**TOWN OF LOS GATOS
PLANNING COMMISSION AGENDA
APRIL 08, 2026
110 EAST MAIN STREET
TOWN COUNCIL CHAMBERS
7:00 PM**

3. Consider a Request for Approval to Demolish an Existing Single-Family Residence and Construct a New Single-Family Residence on Property Zoned R-1:8. **Located at 16724 Chirco Drive.** APN 424-21-025. Architecture and Site Application S-25-002. Categorically Exempt Pursuant to CEQA Guidelines Section 15303: New Construction or Conversion of Small Structures. Property Owner/Applicant: Zahra Kassam. Project Planner: Erin M. Walters.

DATE: April 3, 2026
TO: Planning Commission
FROM: Joel Paulson, Community Development Director
SUBJECT: Consider a Request for Approval to Demolish an Existing Single-Family Residence and Construct a New Single-Family Residence on Property Zoned R-1:8. **Located at 16724 Chirco Drive.** APN 424-21-025. Architecture and Site Application S-25-002. Categorically Exempt Pursuant to CEQA Guidelines Section 15303: New Construction or Conversion of Small Structures. Property Owner/Applicant: Zahra Kassam. Project Planner: Erin M. Walters.

Chirco Drive Residence
Custom One-Story Home
16724 Chirco Dr
Los Gatos, CA 95032
December 9, 2025

PROPOSED PROJECT

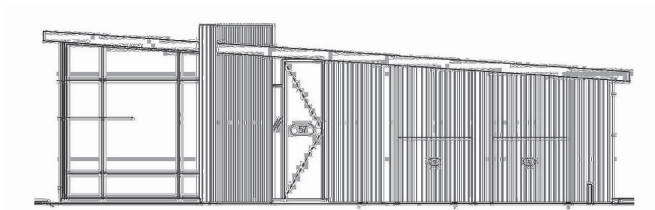
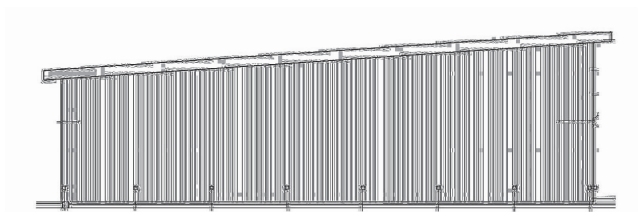
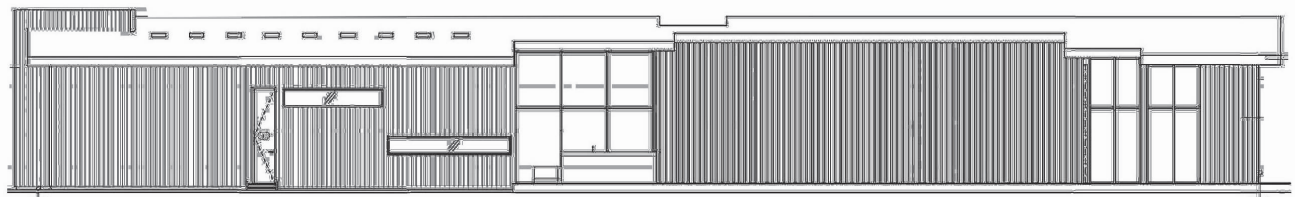
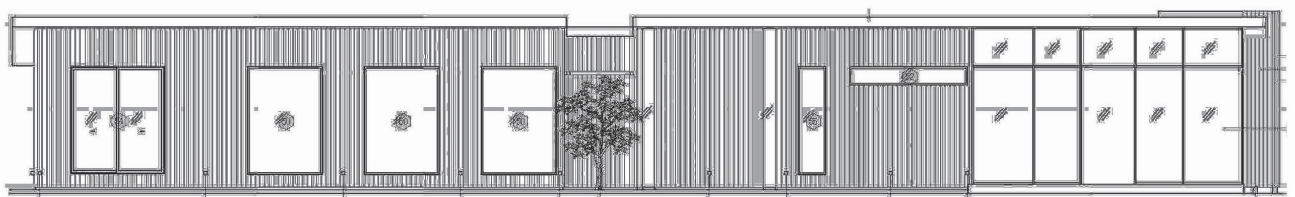
ISSUES AND CONCERNS

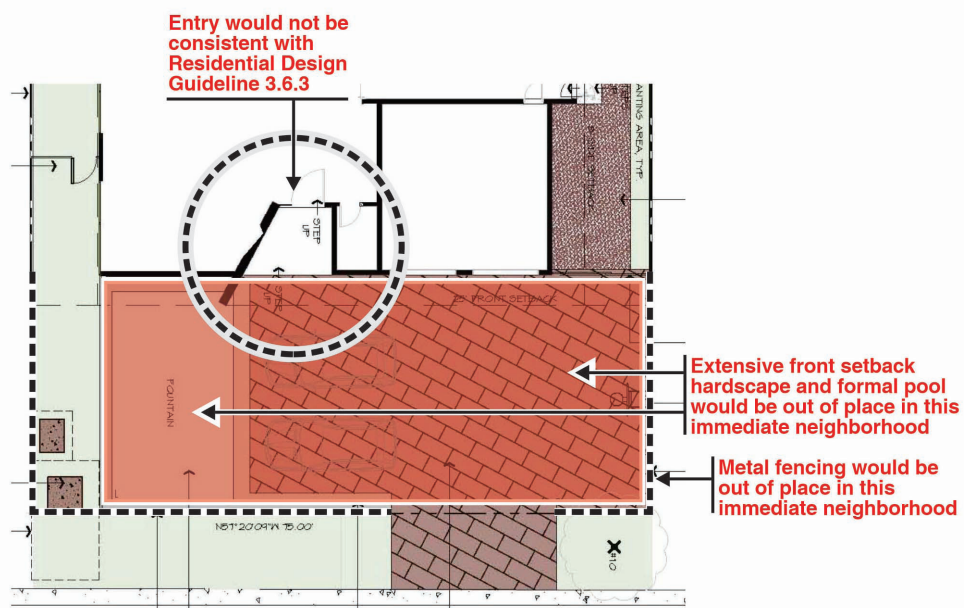
Existing street setbacks are predominately softscape materials except for necessary driveways

Metal fencing would not be consistent with Residential Design Guideline 2.5.3

BURNT WOOD SIDING EXAMPLES

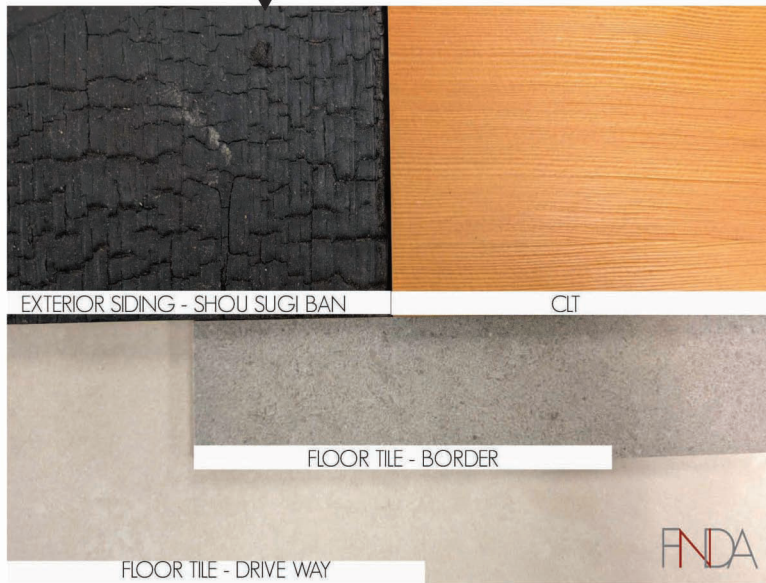
Wood burned siding would not blend well with other homes in the immediate neighborhood and would not be consistent with Residential Design Guideline 3.8.2

TMA Materials have been revised to match the neighborhood. Burned wood has been removed from the scope and replaced with a medium-tone redwood-brown siding, based on the color and materials of neighbors' fences.

ISSUES AND CONCERNS

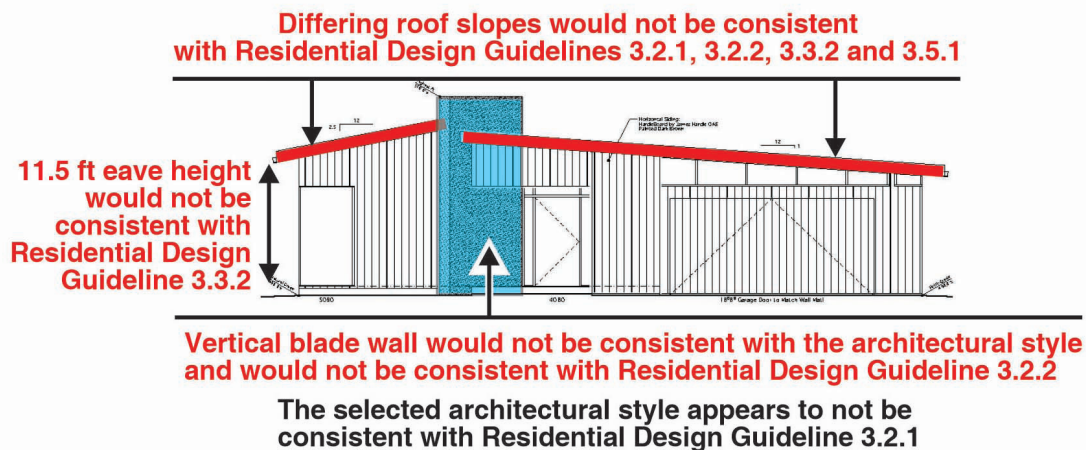
The applicant has made several changes in response to the previous recommendations contained in the review letter of last February. Those change have been positive but may not totally address the issue of neighborhood compatibility as set forth in the town's Residential Design Guidelines.

The proposed home is designed in a Contemporary Style. While a home in that general style might be designed to fit into its immediate neighborhood context, this specific design may be difficult to reconcile with the several of the town's Residential Design Guidelines.

RECOMMENDATIONS

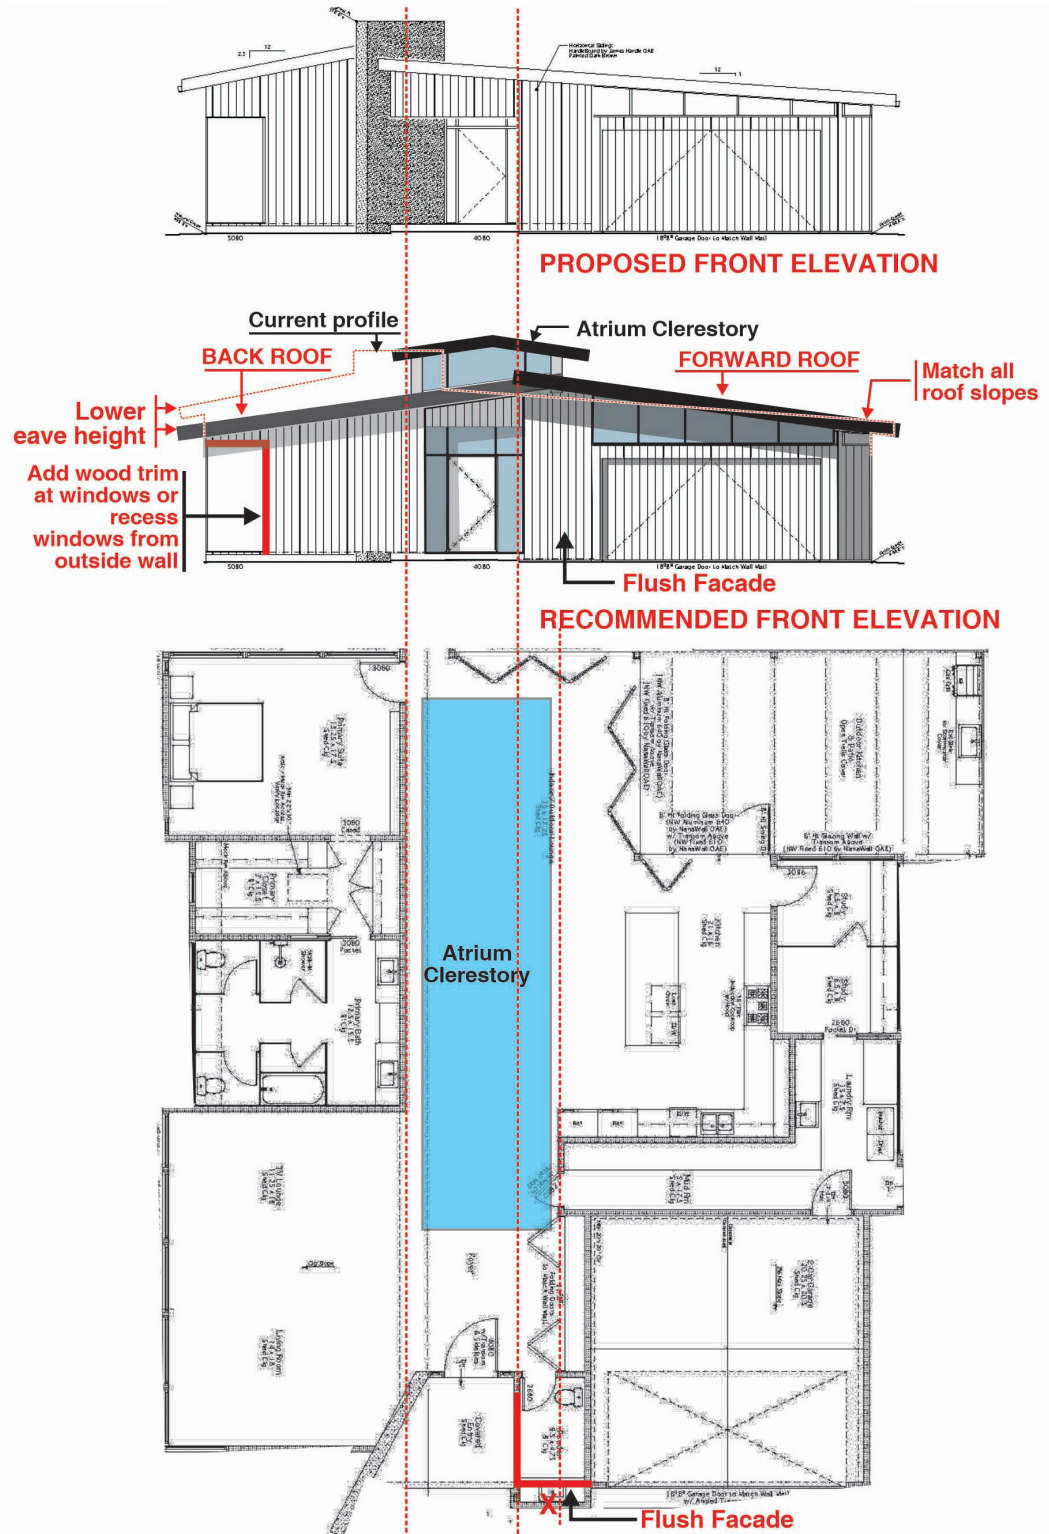
The following recommendation is about as far as I can go in adapting the applicants' preferred design to the immediate neighborhood context. It would still not be totally consistent with the Residential Design Guidelines, but would bring more consistency of the design to the traditional characteristics of the Eichler Style.

1. Unify all roofs with the same roof pitch and consider increasing the slope some to be more complementary to adjacent homes.
2. Substantially lower the eave height on the left side elevation from its currently proposed 11.5 feet.
3. Eliminate the vertical blade wall at the front elevation.
4. Strongly consider the addition a set back atrium with the same roof slope - typical of many Eichler Style homes.
5. Move the front wall of the Powder Room back to align with the adjacent garage wall.
6. Add wood trim to all windows, consistent with Residential Design Guideline 3.7.4 or recess the windows from the adjacent wall facade.
7. Reevaluate the proposed color for the home. Selecting a color or combination of colors related to other homes in the immediate neighborhood or to the traditional colors of Eichler Styles homes would be a better approach.

Applicant's Response: Left side slope has been increased slightly to complement the adjacent roofline. We would like to maintain the asymmetrical contrast as an important element of contemporary design.
